FINAL ENVIRONMENTAL IMPACT STATEMENT OF THE PROPOSED GROUND BASED FREE ELECTRON LASER TECHNOLOGY INTEGRATION EXPERIMENT WHITE SANDS MISSILE RANGE NEW MEXICO

Title of Proposed Action: Ground Based Free Electron Laser
Technology Integration Experiment

Document Designation: Final EIS

Figure I-2. WSMR and Associated Co-Use Areas.

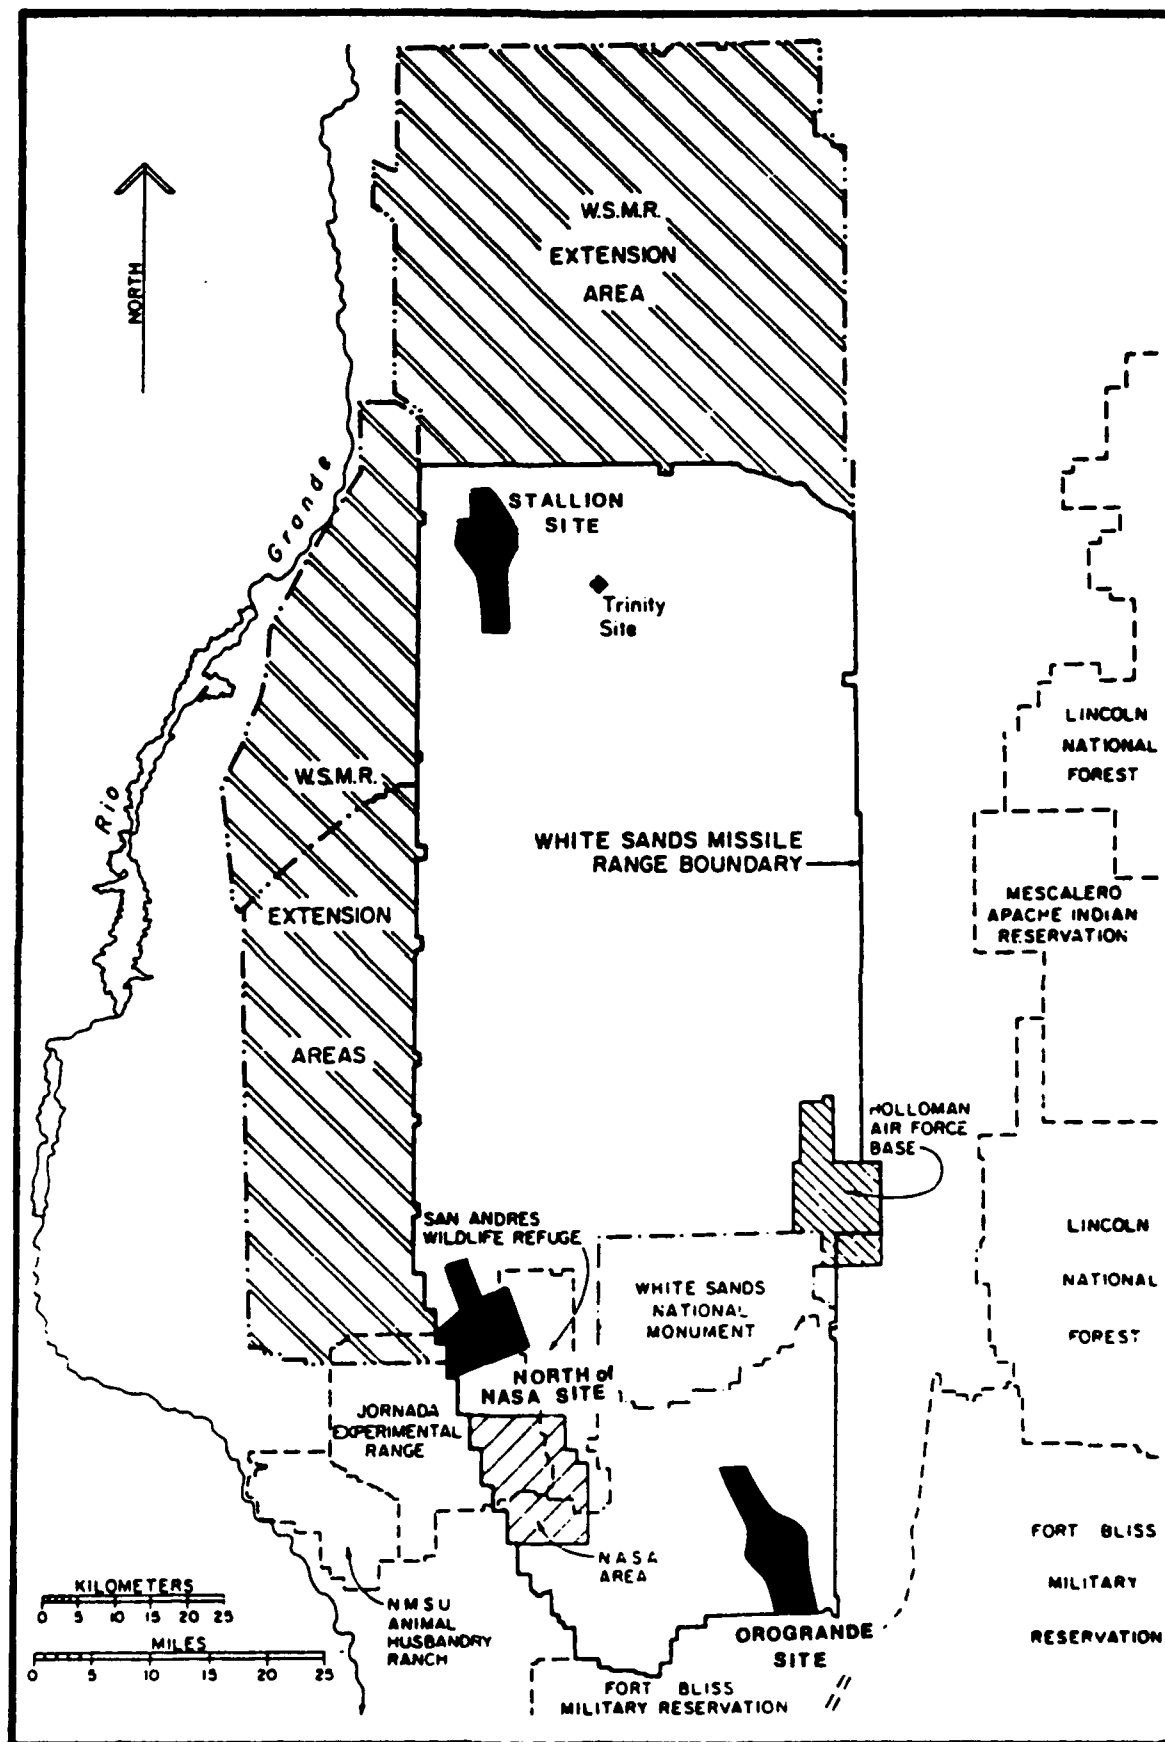
3. The title for Figure 1-2 on page I-3 should be "USNR and associated U.S. Department of the Interior co-use areas." The USNR extension areas are covered by a memorandum of understanding (MOU) dated February 16, 1973, between the Department of the Army and the U.S. Department of the Interior (BLM and USNR).

M-1.3 This correction has been made to the indicated figure (Figure 1-2).

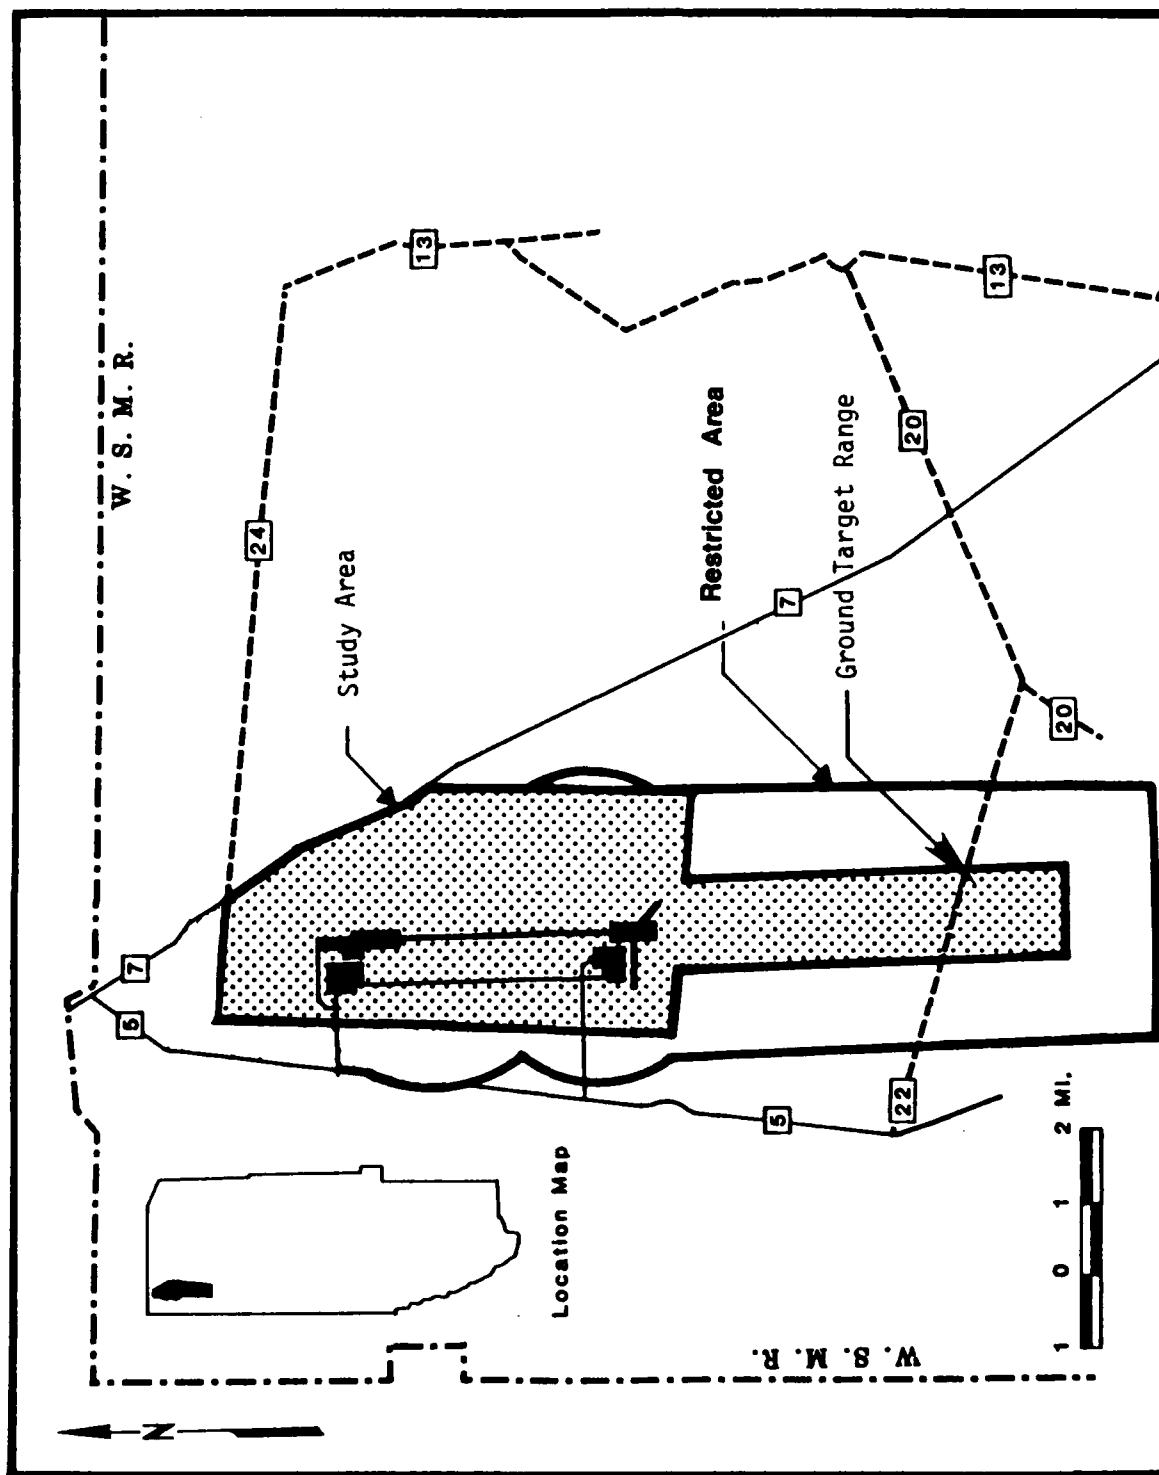
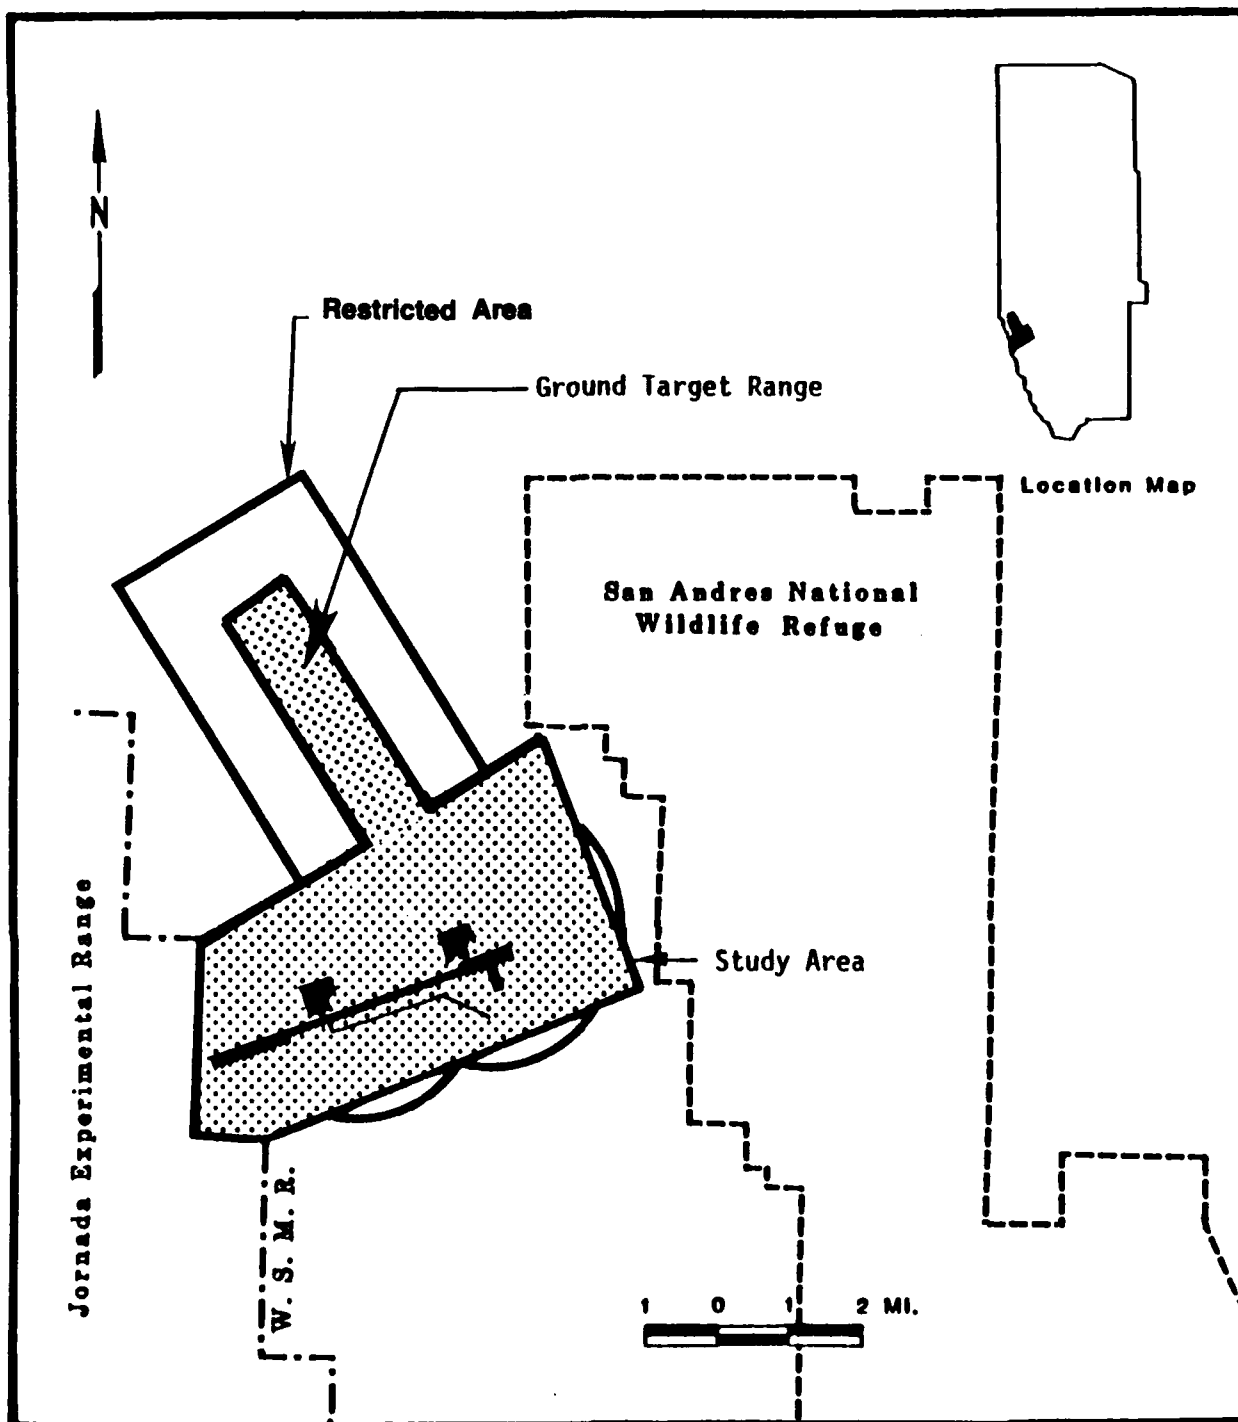
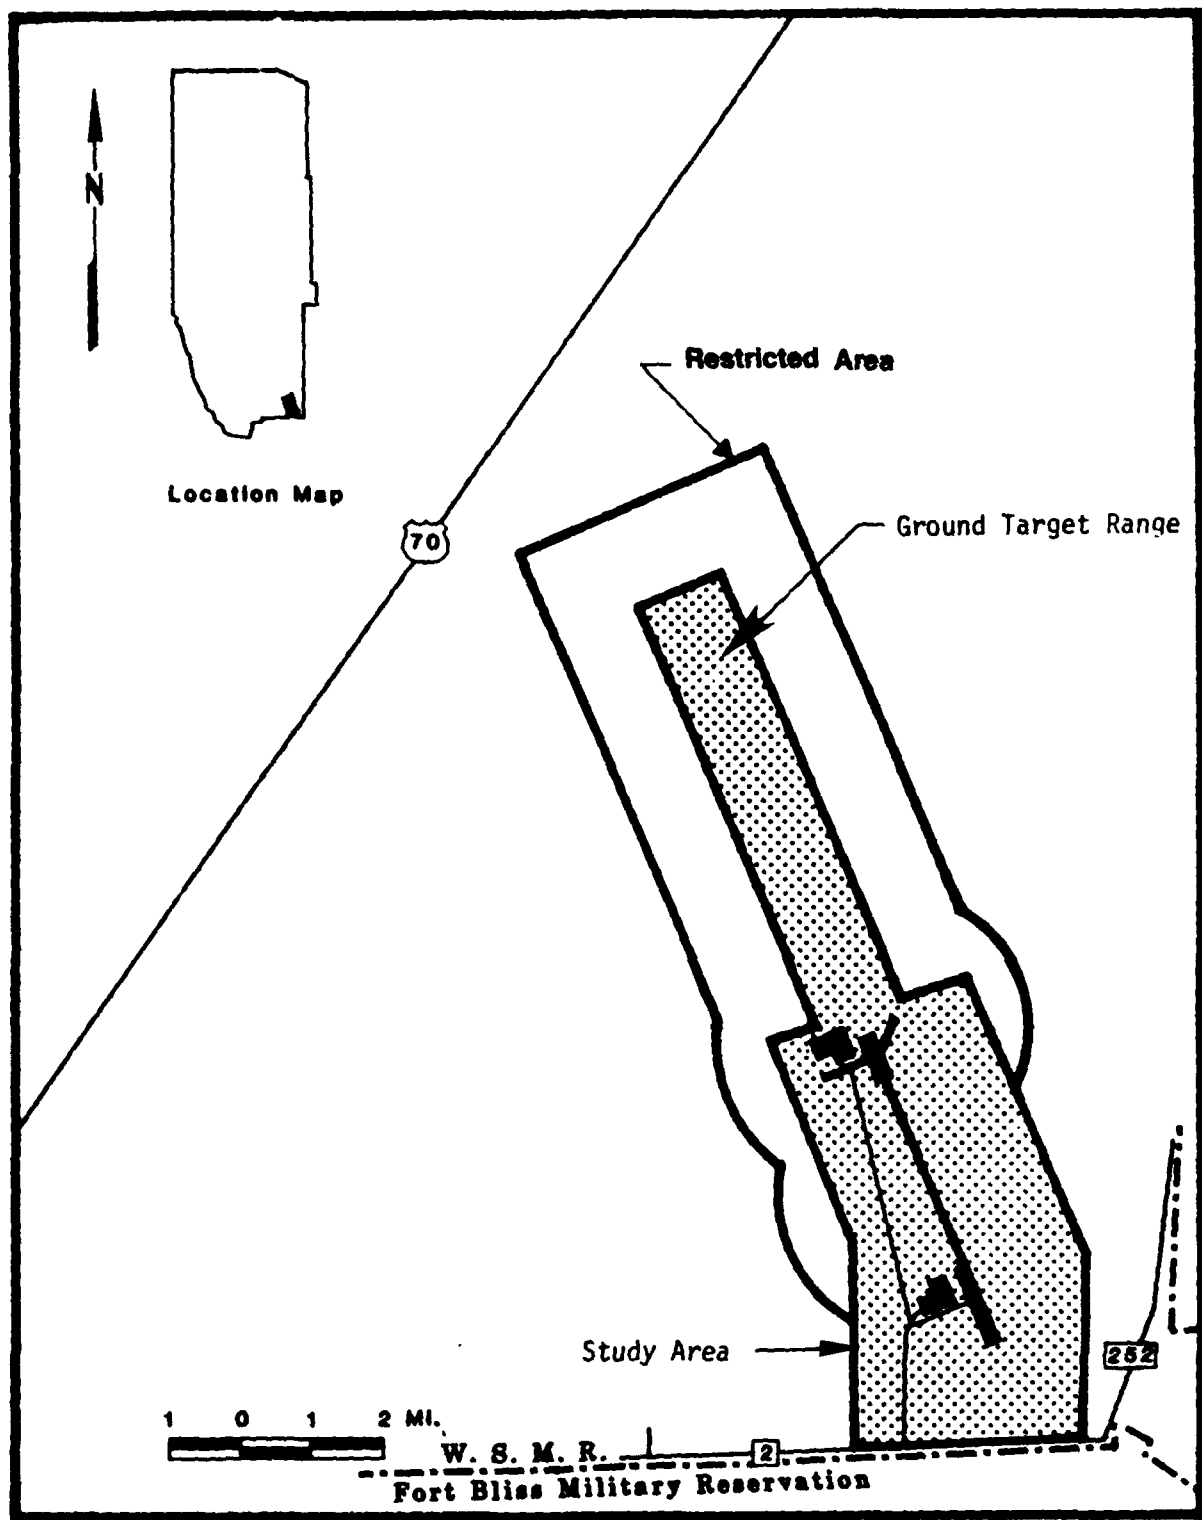
- a. Page 1-3 through 1-9: The land area descriptions given in paragraph B.1. on page 1-3 are different than those shown in Figure 1-4, 1-5 and 1-6. This must be corrected.
